**From:** Borski, Jennifer - DNR  
**Sent:** Wednesday, July 7, 2021 5:11 PM  
**To:** Beggs, Tauren R - DNR; Hedman, Curtis J - DHS; Kloczko, Nathan F - DHS  
**Cc:** Schultz, Josie M - DNR  
**Subject:** VI Discussion/DHS Consult for Jagemann Plating Co Inc, BRRTS #02-36-55544  
**Attachments:** Status Update Email Attachments 062121.pdf

**TABLE A.4  
VAPOR ANALYTICAL TABLE  
JAGEMANN PLATING COMPANY, 1324 SOUTH 26TH STREET, MANITOWOC, WI**

**JAGEMANN PLATING COMPANY**  
**1324 S. 26TH STREET**  
**MANITOWOC, WI**

**VAPOR INTRUSION MAP**

FIGURE B.4.a

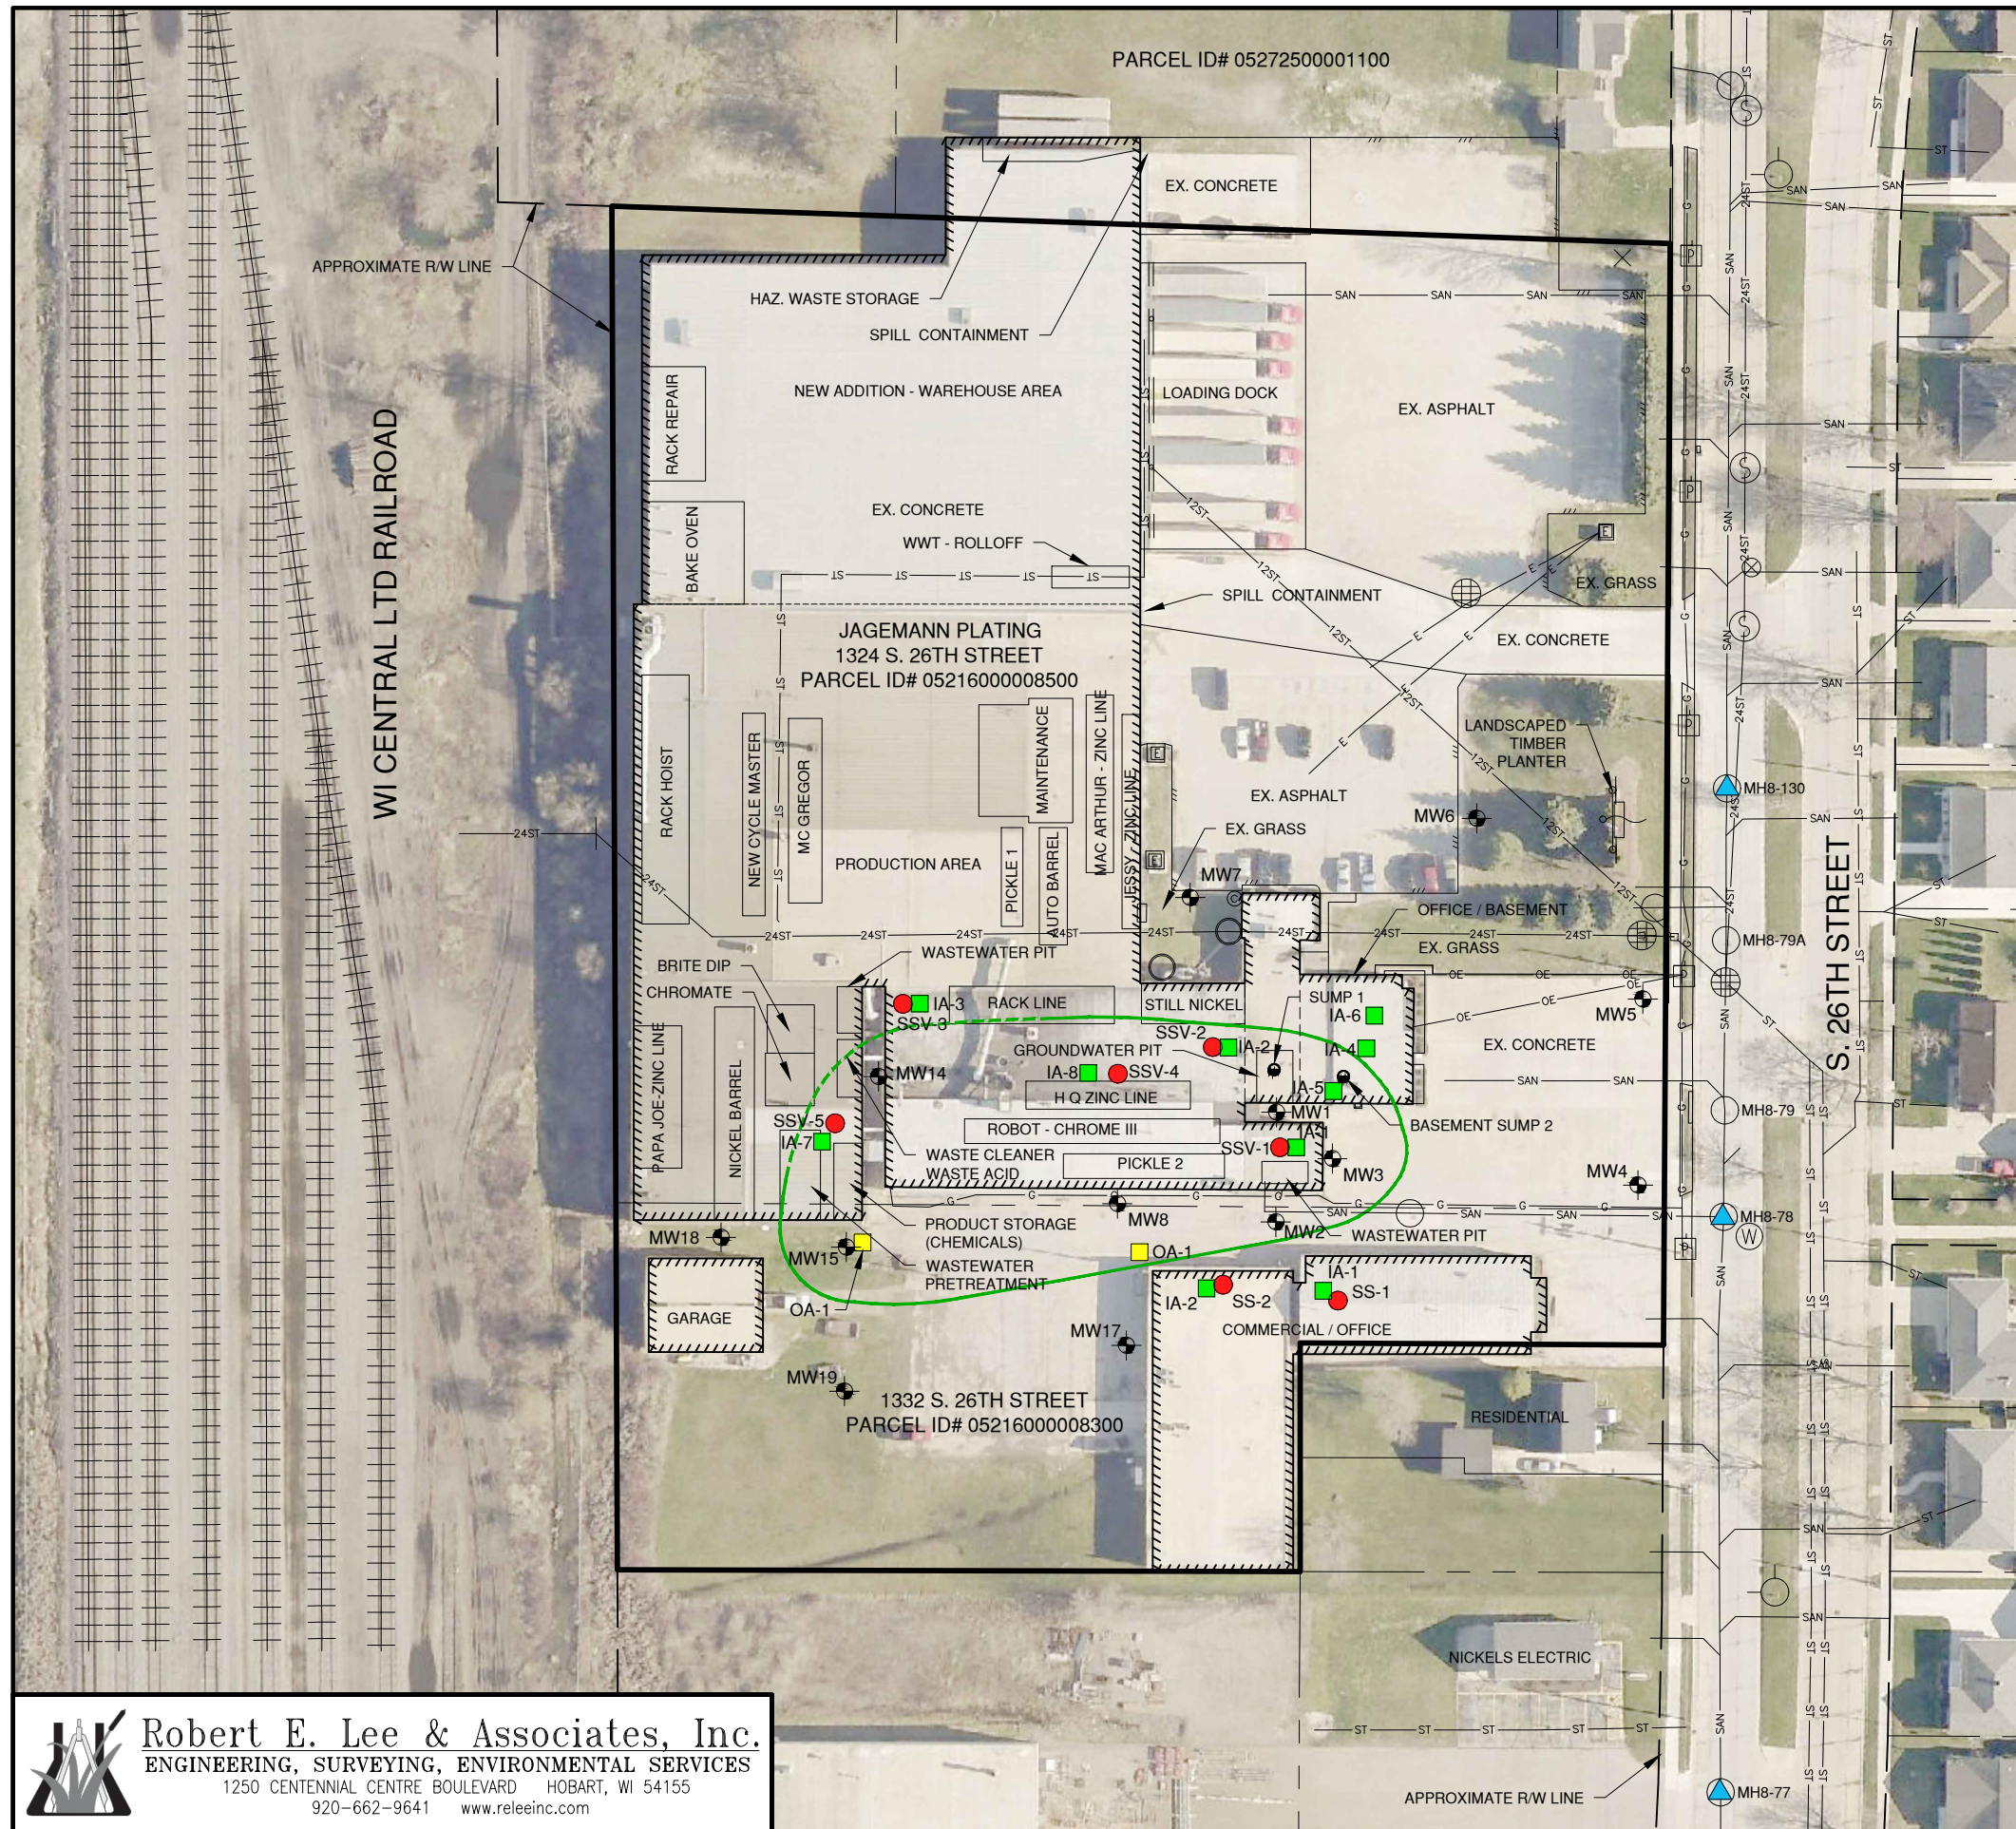
Thank you for discussing the Jagemann Plating Co Inc site with us this afternoon. We reviewed the attached site map and vapor data along with an aerial photo of the area. We understand this is an active plating business and the RP is slowly proceeding with the required investigation. A vapor mitigation system was installed in the office area in 2015 and a subsequent SSV and indoor air investigation took place in 2021, including a utility investigation. SSV in May 2021 revealed TCE at 31,700,000 ug/m3 (1,1,-DCE & vinyl chloride also above VRSL) beneath the main manufacturing floor at SSV-4 but indoor air is below industrial VALs. No additional interim or remedial actions have taken place.

Based on our review and discussion, DNR and DHS are in agreement that a vapor mitigation system is needed and that routine indoor air monitoring should take place until a mitigation system is installed that protects the occupants from sub-slab vapor. Based on [DHS's March 25, 2021 letter](#) (item #3a), an interim action is recommended to be installed within 4-8 weeks.

Sub-slab vapor, indoor air, and in-pipe sanitary sewer sampling has been completed at this industrial plating site. Please see the attached PDF for figures and tables and the email from the consultant below. I will summarize the various sampling that was completed:

Indoor air sampling in office areas where the vapor mitigation system is operating  
Three indoor air samples (IA-4 to IA-6) were collected by Robert E Lee & Associates (REL) in the eastern office area to determine if the vapor mitigation system that was previously installed was effective since indoor air sampling was not previously

completed after the vapor mitigation system was installed. IA-4 had a J flagged detect, but it was below all VALs. The other two samples IA-5 and IA-6 had no detections. REL is also currently looking to coordinate with a new contractor to conduct an inspection of the vapor mitigation system.

Existing vapor ports (SSV-1 to SSV-3) were sampled again. Sub-slab concentrations for SSV-1 and SSV-3 decreased and were not above VRSLs. SSV-2 continues to be above VRSLs.

Two new vapor ports (SSV-4 and SSV-5) were sampled twice, in March and May 2021. **SSV-4 was elevated and SSV-5 was extremely elevated. Paired indoor air samples (IA-7 and IA-8) were collected in May 2021 and both samples were below the industrial VAL. IA-8 was above the residential VAL though. It does not currently appear that the extremely high concentrations of TCE are translating to elevated indoor air concentrations. This may be due to the facility's ventilation system. DNR should provide these results to DHS so they are aware. Is anything else needed at this time?**

Vapor sampling was completed in the sanitary sewer at the manhole directly adjacent to the site and the up and down gradient directions. There were low level detections in the manhole directly adjacent to the site, but they were below the sewer gas screening level. The up and down gradient samples had no detections.

- DNR will need to make clear that, per code, an interim action is needed as well as a remedial action to reduce the mass and concentration of contamination.
